Designed: 08-06-09
INSTALL CANTILEVER AND MEDIAN GATES FOR ROAD EXPANSION.

UNION PACIFIC RAILROAD
PALATINE, ILLINOIS
PALATINE ROAD
HARVARD SUBDIVISION
Office of Sr AVP Engineering - Signal/TCO Omaha, Nebraska

Sh.: 1
DOT 176937T
MP: 26.04
ID: HAR2604.1X

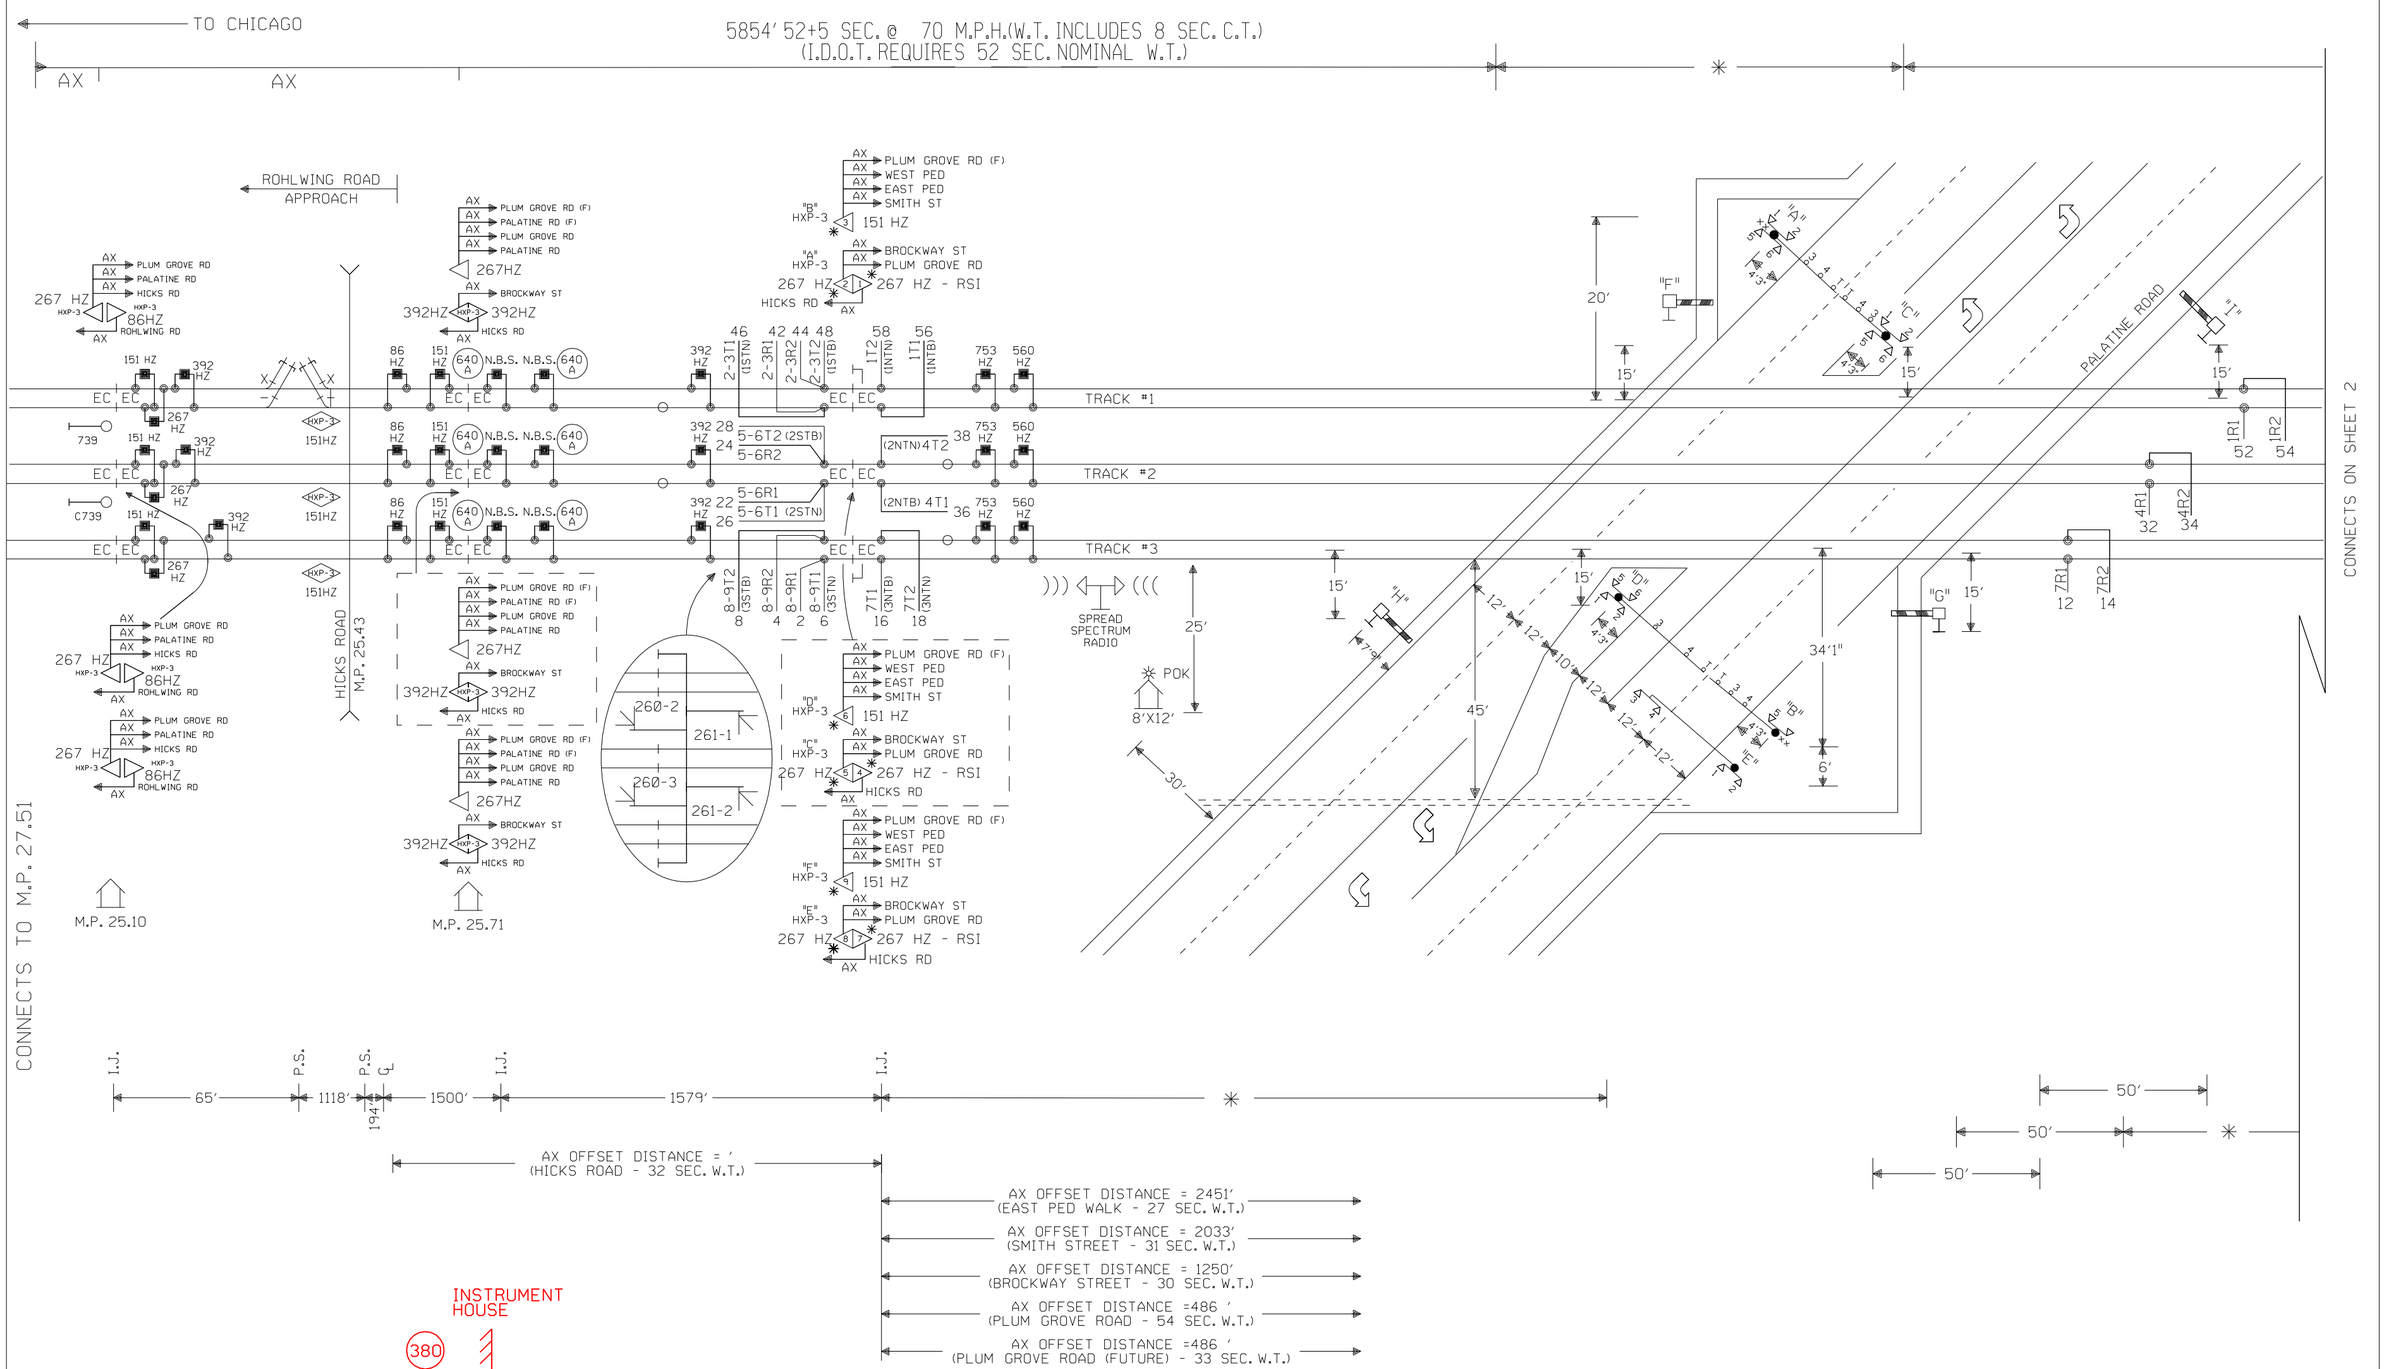
FIELD VERIFY THE OFFSETS, AND "AC" ACCORDINGLY.

1. ✳ = FIELD VERIFY
2. FIELD MOVE TRACK WIRES 50' FROM EDGE OFF THE ROAD.
3. MINIMUM ISLAND 120'

DATE 3-21-00
SHEET 6
DWG 26.04
HAR

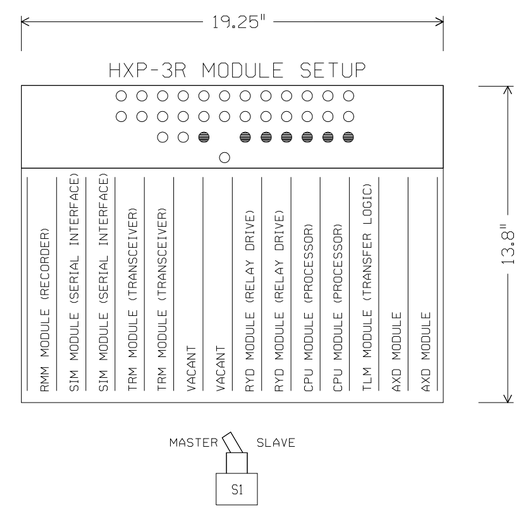
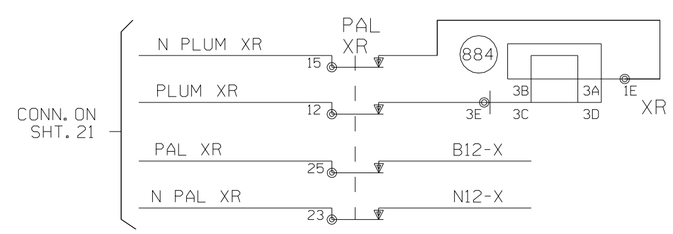
INCREASE WARNING TIME 2 SEC. FOR AX1 & AX2 DUE TO HD LINK PROPAGATION DELAY

HOLD DOWN FOR PALATINE RD. AND PLUM GROVE RD. FOR TIR
